# SERVICE BULLETIN

**Service Bulletin No.:** DAC1-33-04 Rev 2

**Title:** Installation of Backlighting on the Instrument Panel

**3. General:** This Service Bulletin gives the necessary instructions for the installation of backlighting to the Engine Gauges and the Flight Instruments.  
Revision 2 of this Service Bulletin adds aircraft S/N C0611 to the Effectivity range.

Figure 1

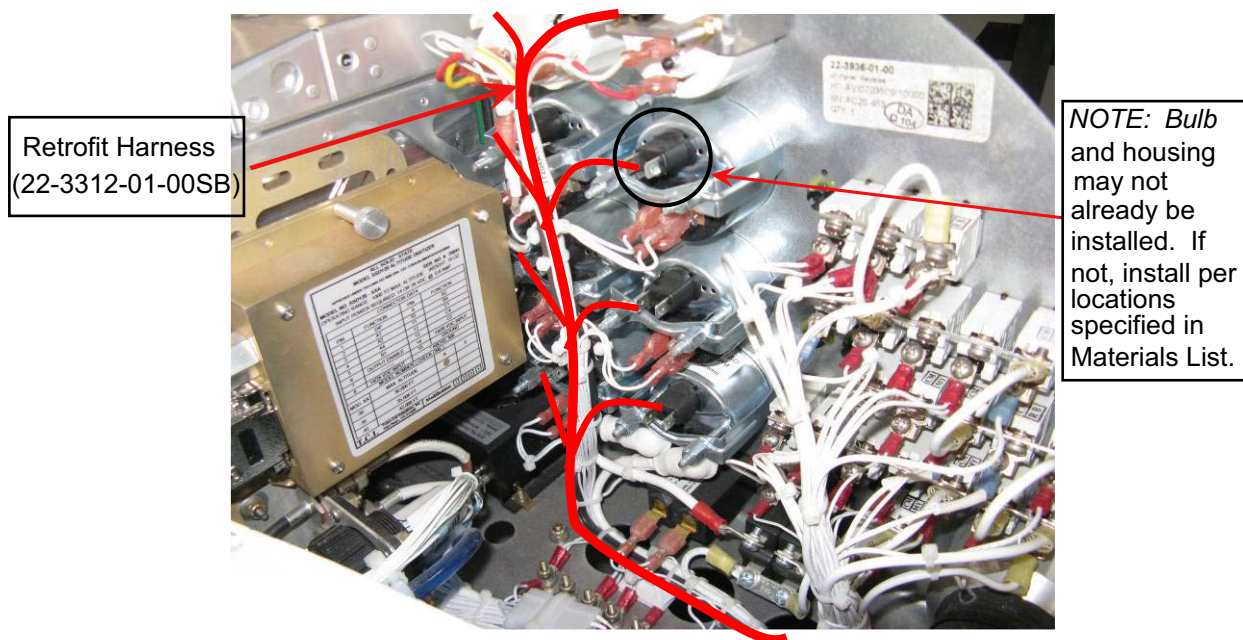
- 10.1 Disconnect the aircraft battery. Refer to AMM Chapter 24-31-00.
- 10.2 Remove the instrument panel cover. Refer to AMM Chapter 25-10-00.
- 10.3 Pull the Battery circuit breaker located on the right side of the instrument panel.
- 10.4 Route the Backlighting retrofit harness (P/N 22-3312-01-00SB) onto the existing instrument panel harness starting at the engine gauges as shown in Figure 1.

Figure 2

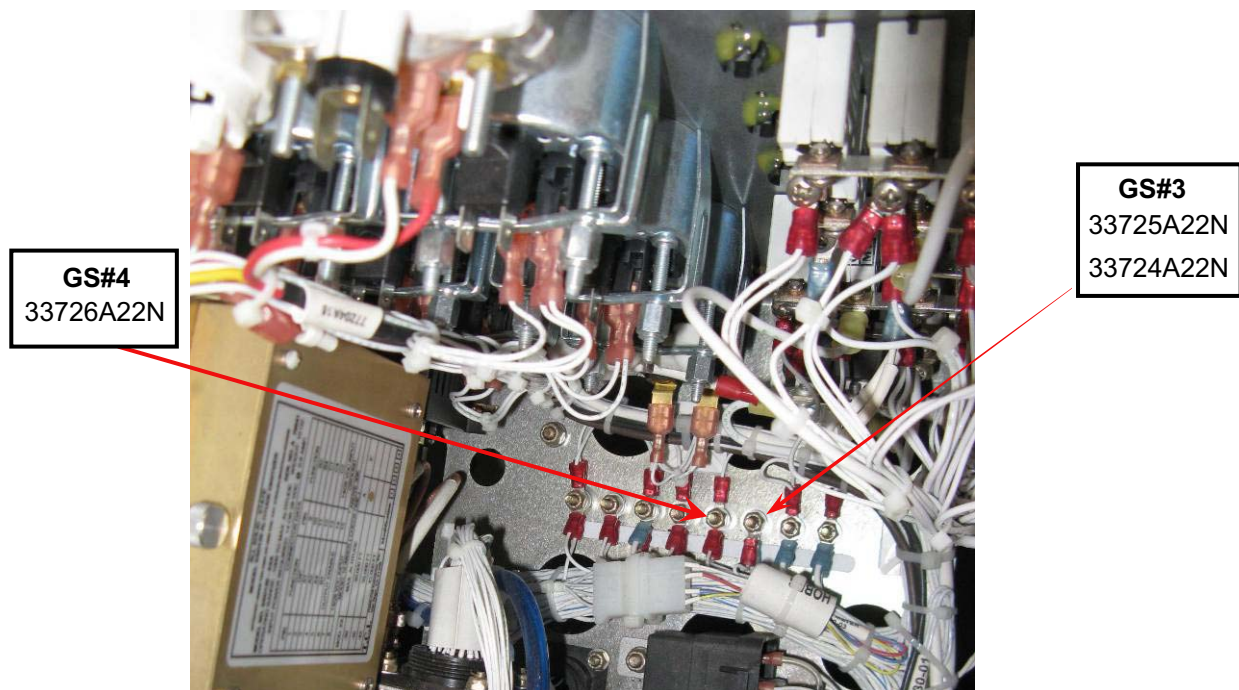
- 10.5 Plug in each Faston contact from the retrofit harness into each bulb of engine gauge matching the label on the harness to the engine gauge.
- 10.6 Attach the ground wires as shown in Figure 2.

NOTE: Ground stud numbering placard currently exists in the instrument panel to help locate GS#3 and GS#4.

Figure 3

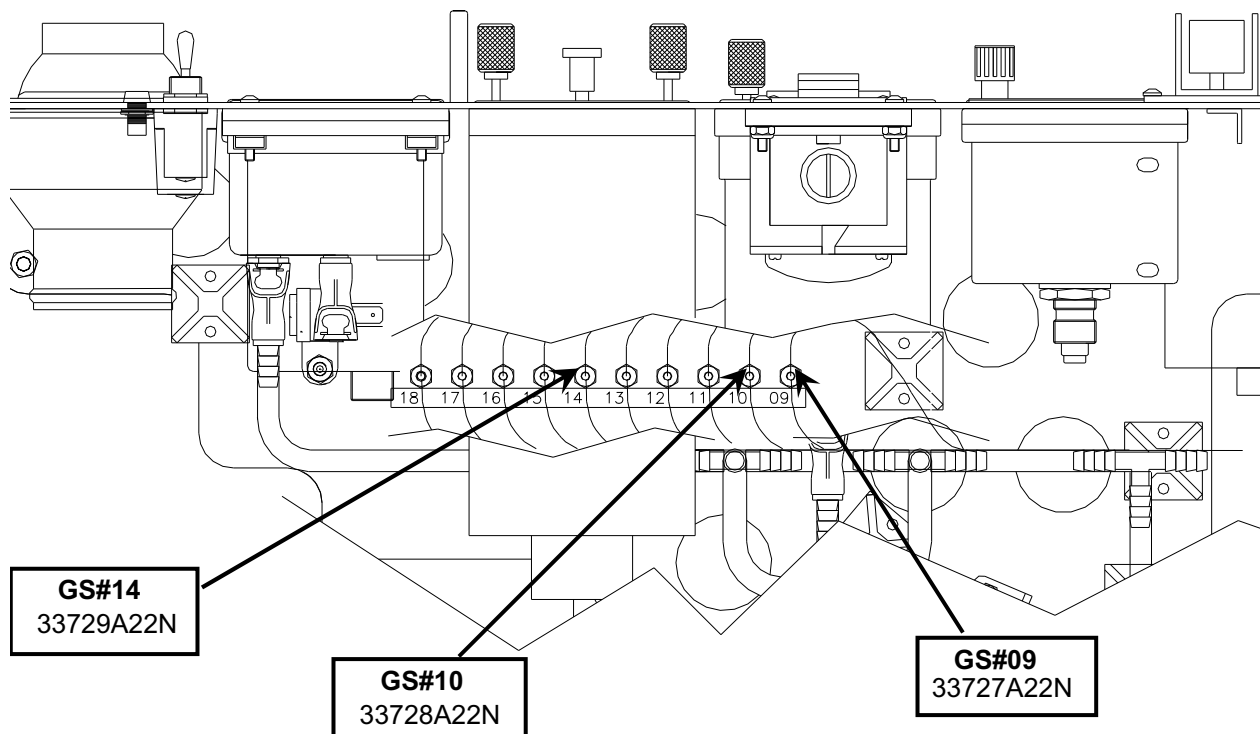
10.9 Attach the ground wires as shown in Figure 3.

Figure 4

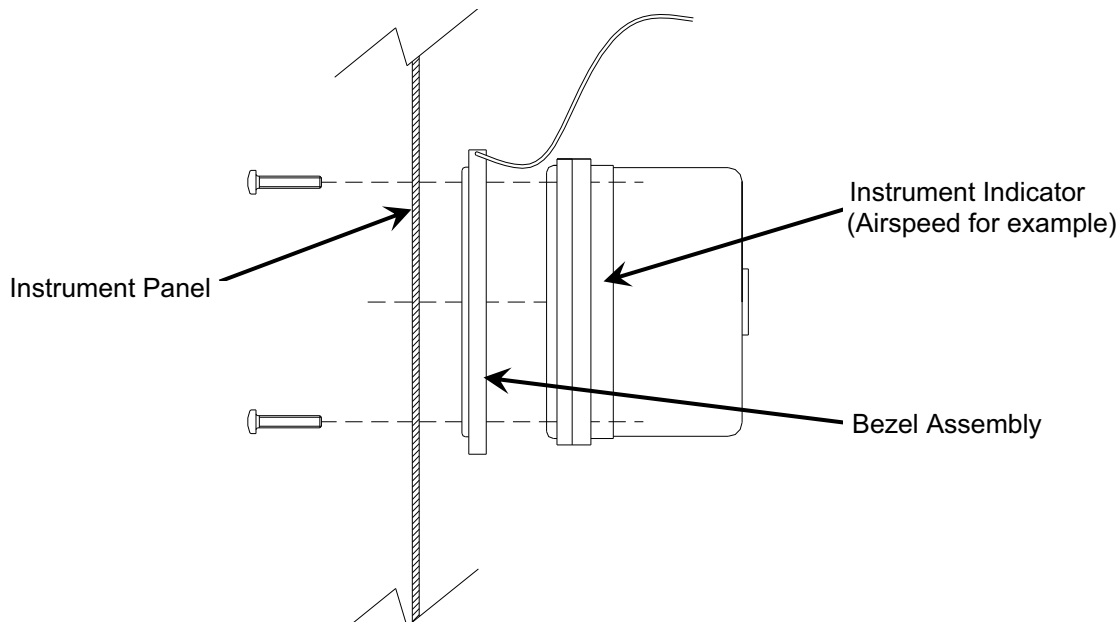
10.10 Install each bezel assembly to the instrument panel and indicator with mounting screws provided. See Figures 4 and 5 that follow for bezel assembly and attaching hardware locations.

Figure 6

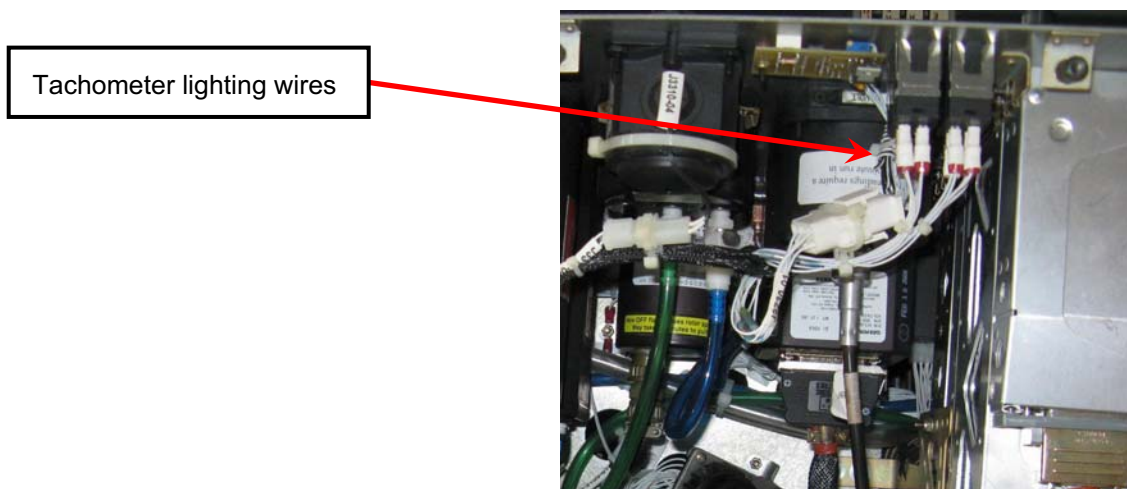
- 10.11 Remove the tied in TACH lighting wires and add expando (P/N 920-1/8" BKWH), contacts (P/N 60618-1) and the connector (P/N 1-480319-0) to the wire ends.

NOTE: Wire may require trimming. See Figure 6 for clarity.

Figure 7

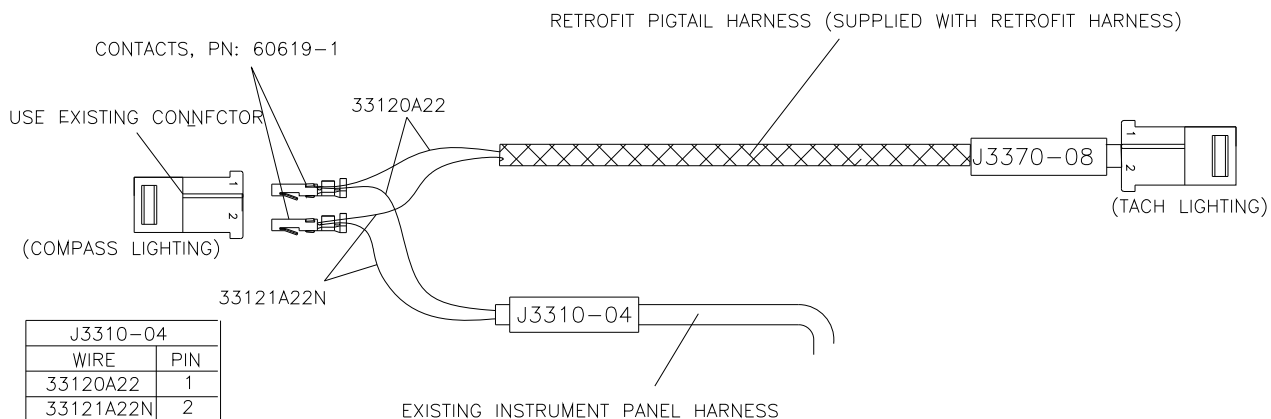
- 10.12 Cut off crimps from the existing J3310-04 (compass lighting) connector located on the existing instrument panel harness.
- 10.13 Crimp retrofit harness pigtail (J3370-08) with J3310-04 wires together as shown in Figure 7.

Figure 8

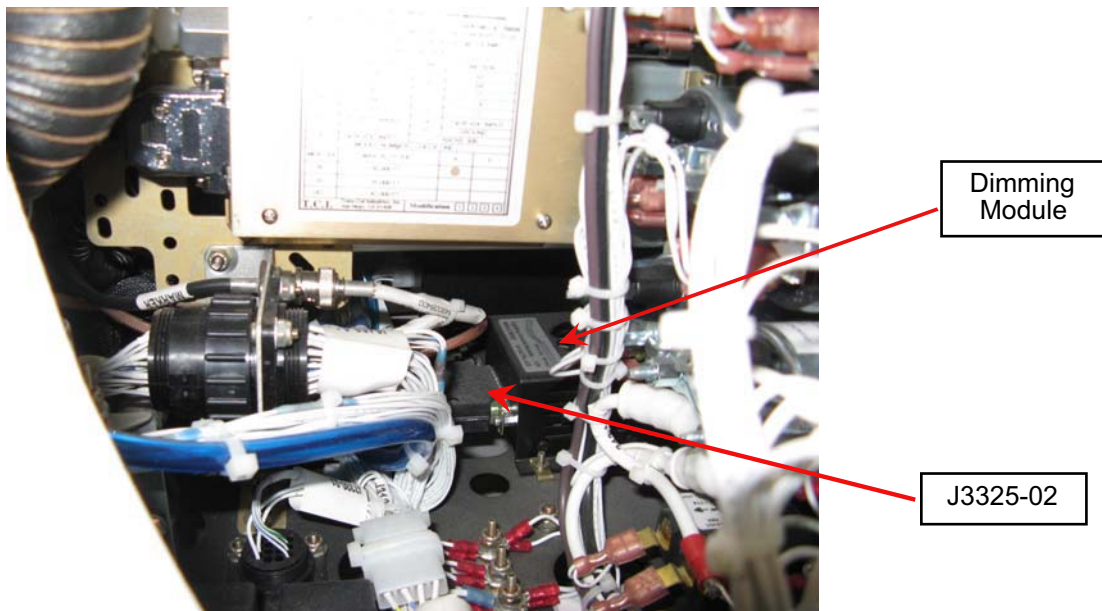
- 10.14 Connect the J3310-04 connector to the compass lighting connector and connect J3370-08 connector to the Tachometer lighting connector. Secure to the instrument panel harness/panel.
- 10.15 Remove the backshell from the existing instrument panel harness connector J3325-02, located below radios. See Figure 8 for location of J3325-02 connector.

- 10.16 Install the following wires, of the retrofit harness, into J3325-02 connector, and assemble the connector and install into the dimming module.

J3325-02	
PINS	WIRE
9	33704A22
10	33707A22
15	33706A22
16	33709A22
21	33705A22
22	33708A22
